**WESTERBEKE**

MARINE ENGINE PRODUCTS

SERVICE BULLETIN 92

DATE: 6 May 1982 BULLETIN NUMBER: 114  
MODEL: All Marine Propulsion Engines  
SUBJECT: Domestic Water Heater Installation Using Westerbeke FLOWCONTROLLER

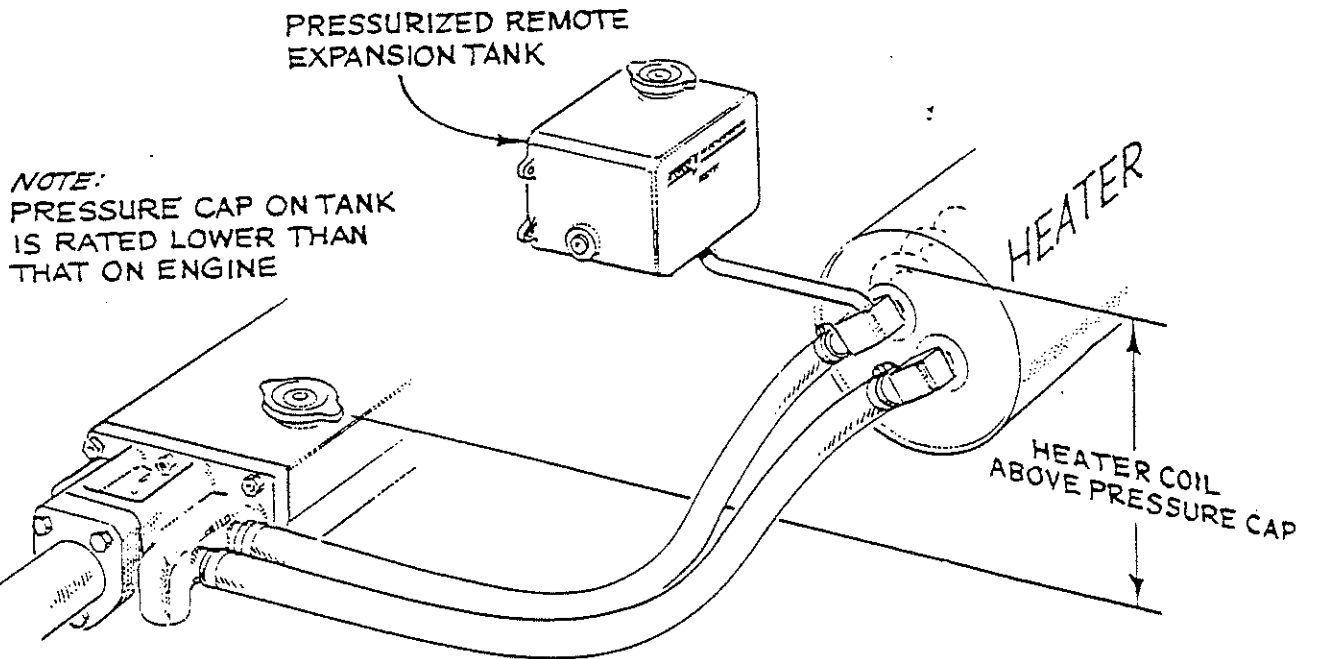
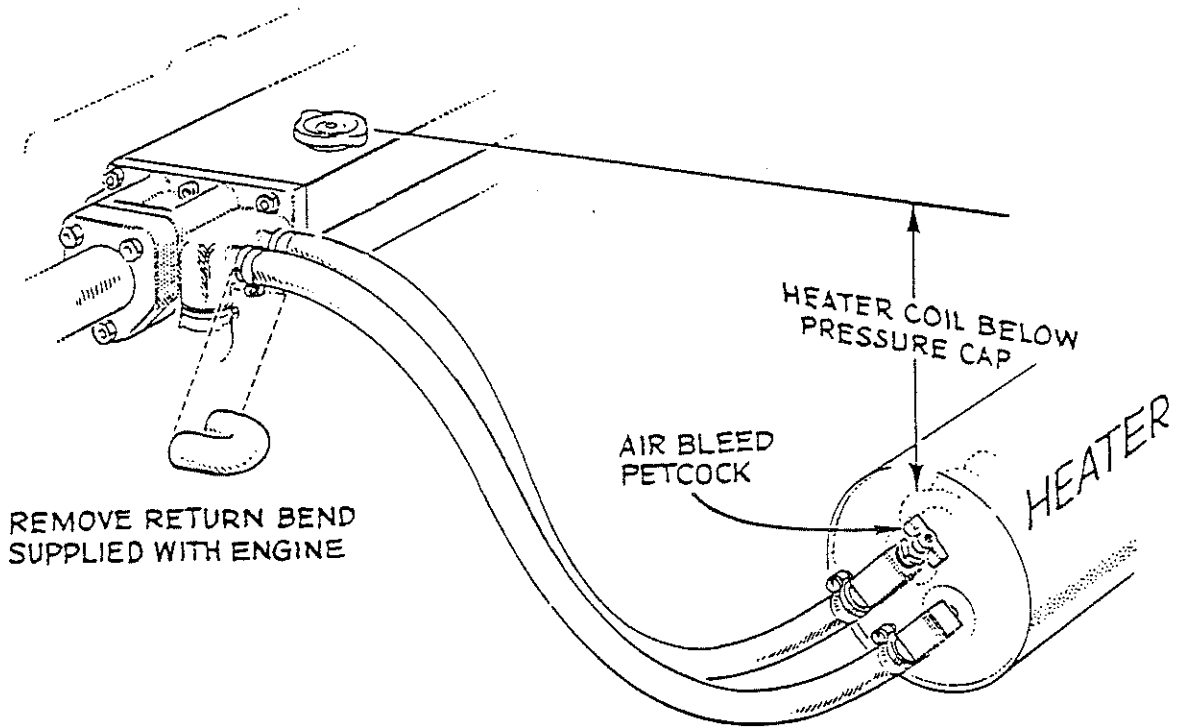
Installation: Remove the return bend which normally connects the 7/8" hose spuds on engines as shipped from the factory. Connect these spuds to the heater with 7/8" ID wire inserted hose. The spud marked "out" indicates the flow from the engine and the spud marked "in" indicates the flow returning to the engine.

Hoses should rise continuously from their low point at the heater and to the engine so that trapped air will rise naturally from the heater to the engine. If trapped air can rise to the heater, then an air bleed petcock must be installed at the higher fitting at the heater for bleeding the air while filling the system. Avoid loops in hose runs which will trap air.

If any portion of the engine cooling water circuit to or from the heater rises above the engine's own pressure cap, then the pressurized remote expansion tank must be installed in the circuit to be the highest point. The tank kit Part Number is 24177. Install the remote expansion tank in a convenient location such as a sail locker for ease of checking fresh water coolant level.

The cap on the engine mounted expansion tank/manifold should not be opened once the system is installed and filled.

The hose connection from the heater to the remote expansion tank should be routed and supported so as to rise continuously from the heater to the tank enabling any air in the system to rise.

## ILLUSTRATION

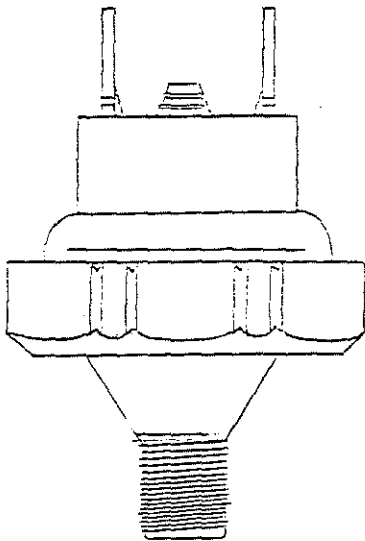
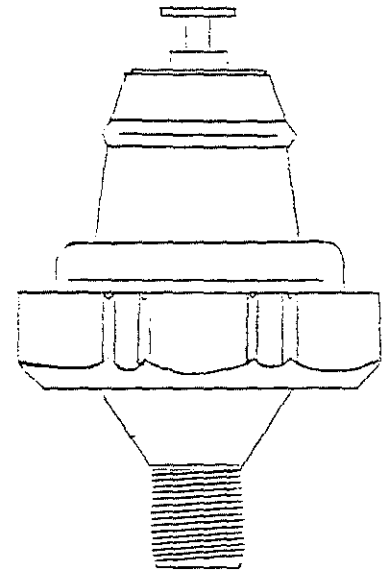
When removing and installing oil pressure switches of the type illustrated below, care should be taken to use the correct type socket specifically designed to correctly fit the metal circumference of these switches.

The correct socket can be acquired through well-known tool manufacturers such as Snap-On, New Britain, Cromwell, Proto and others. The use of channel lock pliers, vise-grips or pipe wrenches, is not advised, in that they may cause damage to the seal between the metal body and the plastic center insert, resulting in a leak and/or switch failure.

SUBJECT: HBW (Short Profile Sailing Gears) Transmission Shift Lever Adjustment

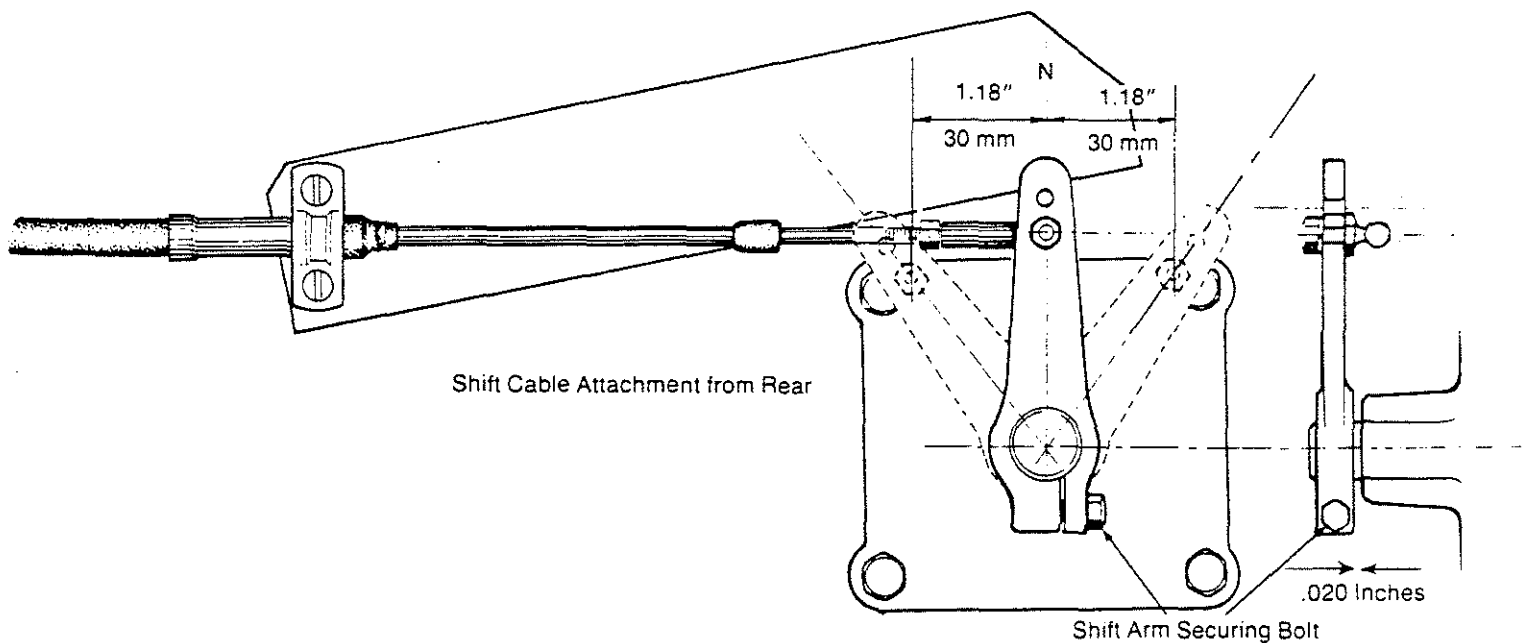
The control cable, when attached to the transmission shift arm ball joint connector, should be attached so as to be at a 90° angle with the lever and transmission in the neutral position (Ref. Illustration).

The transmission shift arm can be rotated on the transmission side cover shifting shaft by loosening the securing bolt (13mm) and rotating the shift arm to produce the 90° angle between the arm and the shift cable when the transmission is in neutral. Insure that there is at least .020 inch clearance between the shift arm and the shift cover before retightening the securing bolt.

The shift cable and pedestal control must allow the transmission shift arm to move from the neutral position into the forward or reverse engagement a MINIMUM of 1.37 inches (35mm) when the outermost ball joint attachment hole is used on the shift arm, or 1.18 inches (30mm) when the inner is used. Use of the inner attachment hole is preferred (Ref. Illustration).

Minimum Travel (inner hole used)

Failure to properly adjust the shift arm and cable to produce the MINIMUM shift arm travel required for clutch engagement will result in clutch slippage and eventual failure.

Adjusting the shift arm and shift cable to produce shift lever movement greater than the minimum is recommended.

Movement at the shift arm preferably should be 1.5 to 2 inches of arm movement into the forward and reverse position. Cockpit controls must be of a design that will allow for this desired cable travel.

LATE MODEL TACHOMETER

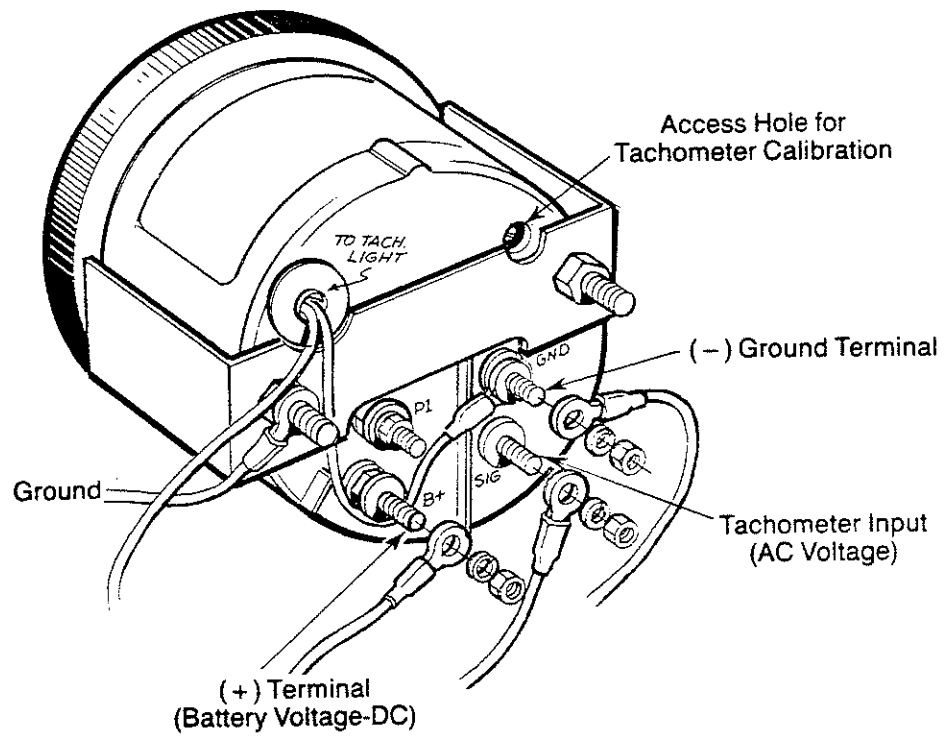
Replaces Earlier Model as Shown on Page 2 of this Bulletin

Alternator Mounting Kit #256891 Components

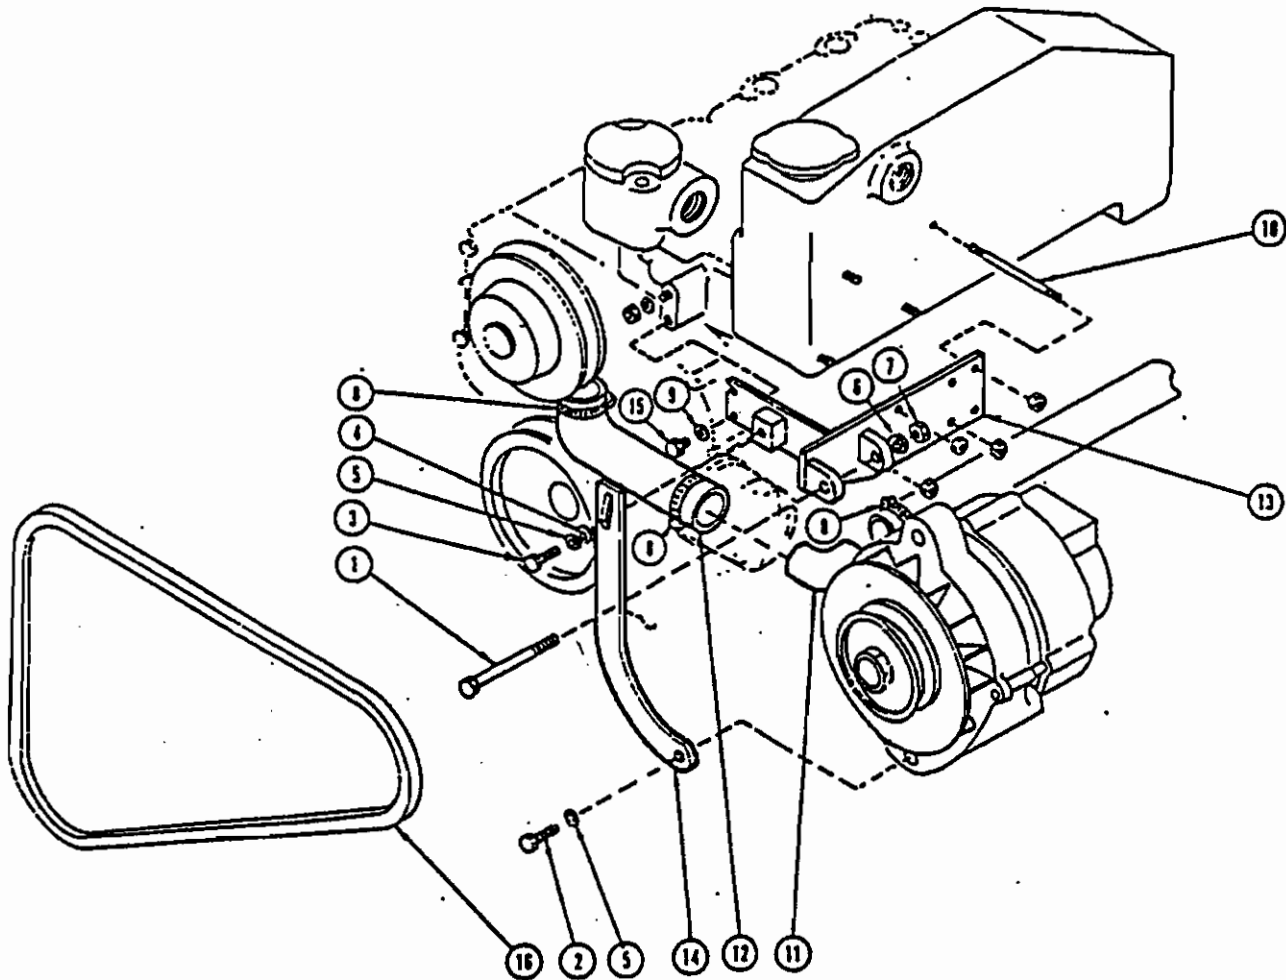
Westerbeke Corporation has become aware that some early model Universal M18, M25 and M25XP marine engines having the DC charging alternator mounted directly to the front gear case cover have experienced failure of the gear case cover at this mounting point.

Owners of these early Universal models are encouraged to inspect their units and if they find the DC charging alternator mounted directly to the front gear case cover that they purchase a conversion kit PN# 256891 that will allow for the mounting of the alternator on a bracket that is attached to the engine's exhaust manifold as later model engines were configured to. The illustration with this bulletin lists the kit components and shows their location on the engine.

Contact your local area Westerbeke/Universal dealer to order the alternator mount conversion kit #256891 and front gear case cover parts as needed.

## Heat Exchanger Group - New Style

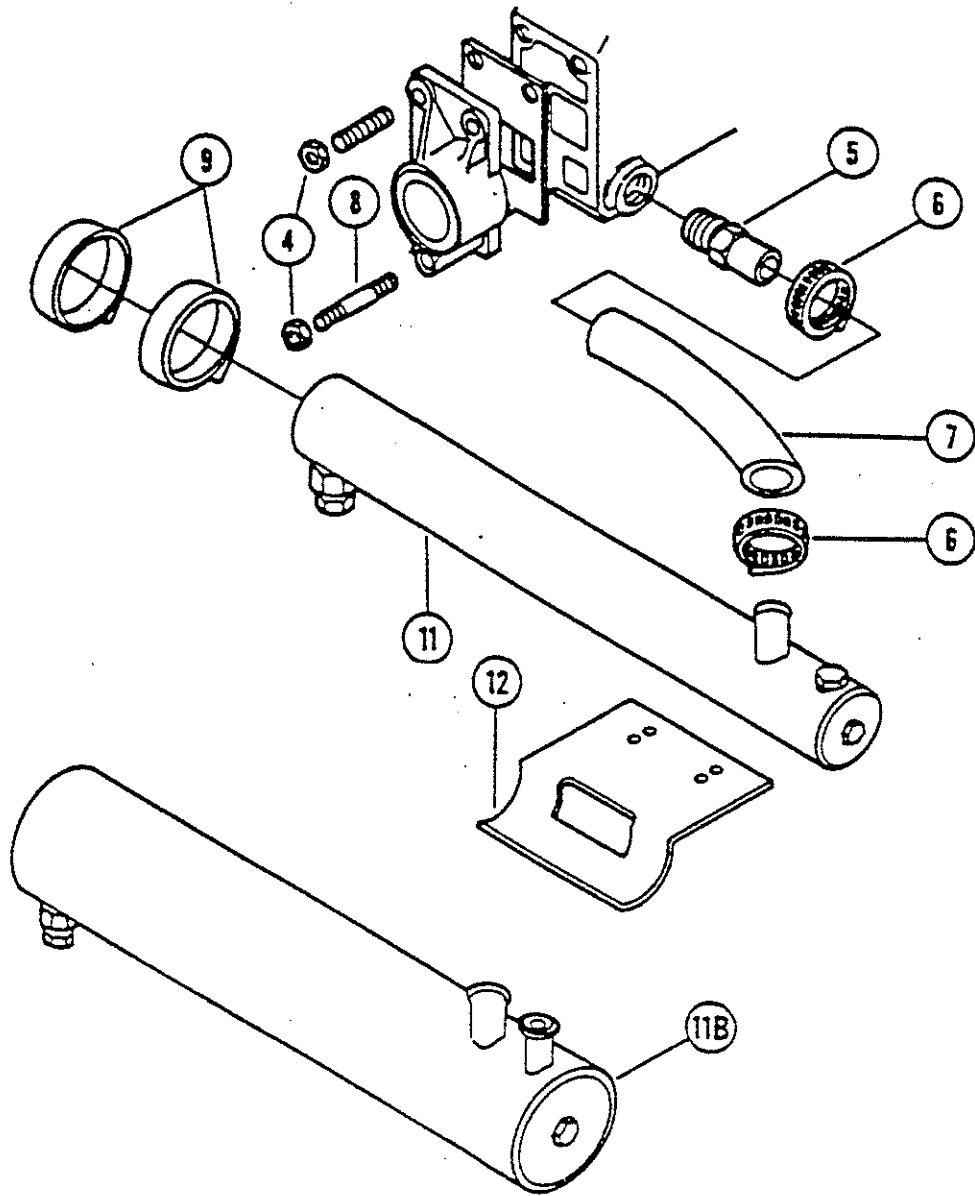
If these areas 1-6 have been inspected and any faults that are found are corrected and overheating still occurs, it is recommended that the operator consider replacing the two inch diameter heat exchanger (P/N #299049) originally supplied with the engine with the three inch diameter heat exchanger Universal incorporated on later models (P/N #299835).

The illustration shows this larger heat exchanger, reference #11B. The contoured mounting bracket reference #12 will have to be reworked to fit the contour of the larger exchanger. This can easily be done by removing the bracket and using a piece of three inch iron pipe as a template to rework the bracket to the proper contour. Use two cushions #033487 between the exchanger body and the bracket along with heavy duty clamps (P/N #303070) when mounting the heat exchanger to the reworked bracket. The illustration helps show these components.

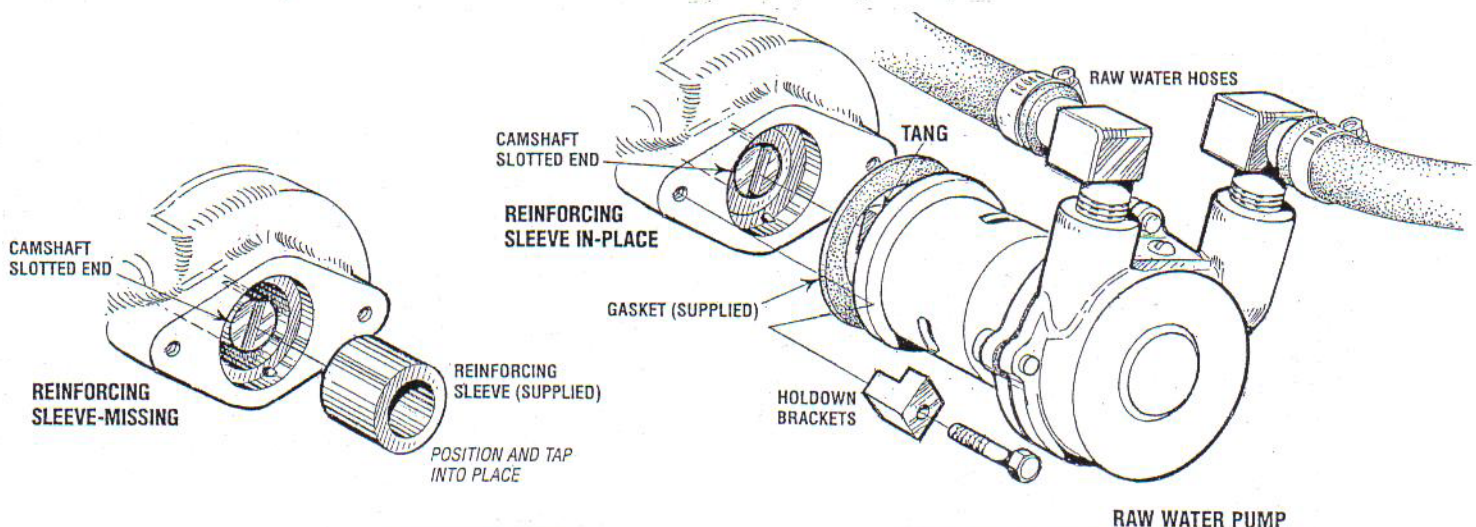
Owner/operators are advised to immediately remove the sea water pump off the front gear case of their engine and inspect the cam shaft sea water pump drive end to make sure it has this reinforcing sleeve. The illustrations show the cam shaft end with and without the reinforcing sleeve.

The reinforcing sleeve is easily installed as it is just a slight force fit fully over the sea water pump drive end of the cam shaft. Position the reinforcing sleeve squarely onto the end of the cam shaft and gently tap/push it fully onto the shaft end so it is flush with the end of the shaft.

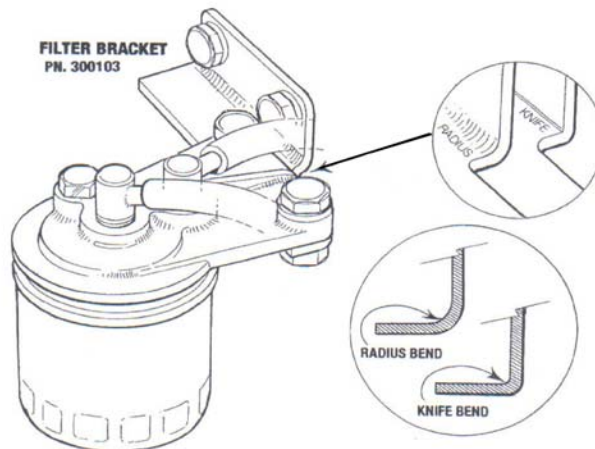
DETAIL: FRACTURES HAVE BEEN REPORTED FROM THE FIELD IN THE AREA OF THE 90-DEGREE BEND

IN THE #300103 BRACKET. INSPECTION OF BRACKETS RETURNED FROM THE FIELD HAS SHOWN THAT THE 90- DEGREE BEND WAS INCORRECTLY PERFORMED USING A KNIFE-EDGE BENDER RATHER THAN A RADIUS BENDER.

THIS KNIFE EDGE BENDING PROCESS PLACES A NOTICEABLE CREASE ALONG THE BEND WHICH CAN STRESS THIS AREA OF THE METAL CREATING THE POSSIBILITY OF A FRACTURE TAKING PLACE ALONG THIS CREASE.

THE ILLUSTRATION BELOW SHOULD HELP TO SHOW THE DIFFERENCES IN THE 90 DEGREE BEND.

THE ABOVE SUBJECT MODELS USING THIS BRACKET MANUFACTURED PRIOR TO SEPTEMBER 2004 (E409) ARE SUSPECT. VISUALLY INSPECT THE BRACKET AND IF A CREASE IS VISIBLE ALONG THE BEND AREA. CONTACT WESTERBEKE CORPORATION AT 508-823-7677. PROVIDE THE ENGINE MODEL AND SERIAL NUMBER AND A SHIPPING ADDRESS AND A REPLACEMENT BRACKET WILL BE SENT AT NO CHARGE.

**CYLINDER HEAD GROUP**

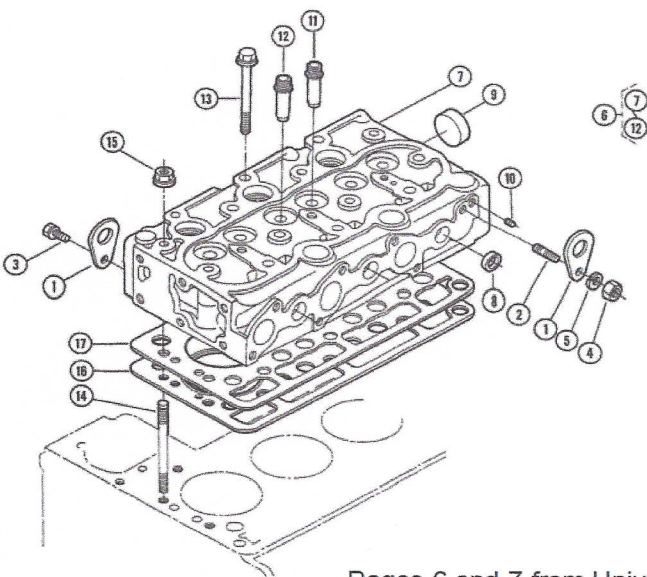
DETAIL: Confusion regarding when to use the cylinder head shim, reference 17 illustrated below, included in complete or upper gasket sets for the M25 and M25XP products has prompted the following explanation of when use of the shim is required.

Upon assembly of the engine by the manufacturer the cylinder head to piston top height clearance is measured to determine if a shim is needed. This results in inconsistency from one engine to the next. When replacing the cylinder head gasket on the subject models pay attention to whether a shim was originally used. Be sure to use the new shim if one originally existed in order to avoid the possibility of interference issues.

In the event you did not disassemble the engine and you do not know if a shim was used originally we recommend both the gasket and shim be installed to avoid problems. Installing a shim in either case is acceptable and preferred.
